National Committee on Uniform Traffic Control Devices

NCUTCD Proposal for Changes to the Manual on Uniform Traffic Control Devices

ITEM NUMBER: 18B-RW-02

TOPIC: R10-XX, LEFT (RIGHT) TURN YIELD ON FLASHING YELLOW ARROW signs for signals with permissive left turns

Figure 2. The percentage of participants selecting each sign alternative at each ranking value.

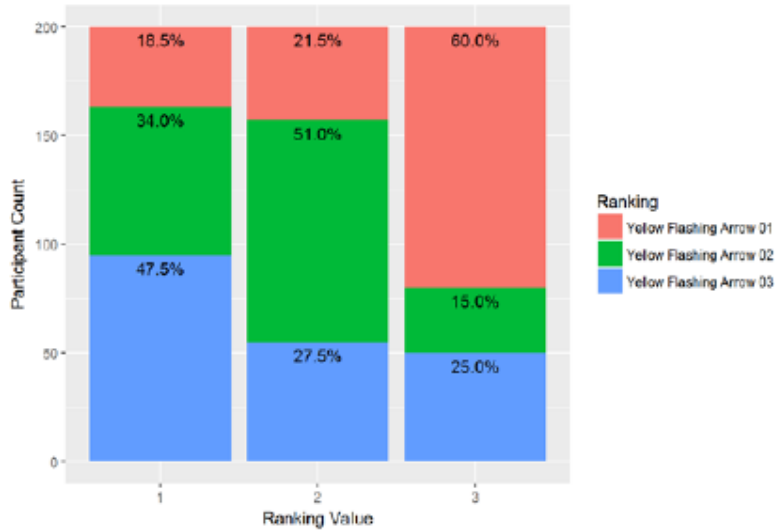
75
 76
 77 Next, participants were told the intended meaning of the flashing yellow arrow sign. The three
 78 sign alternatives were presented (i.e., no blank sign was shown for ranking) and participants
 79 were asked to rank them in terms of perceived effectiveness. When considering only the top
 80 choice indicated by the participants (Ranking = 1), alternative 3 was selected as the top choice by
 81 47.5 percent (95/200) of the participants and alternative 2 was selected as the top choice by 34
 82 percent (68/200) of the participants. There was a significant difference in the rankings of each
 83 alternative $\chi^2(4) = 121.44, p < .001$. Alternative 1 (all text) was consistently rated the least
 84 effective sign ($p < .05$)
 85
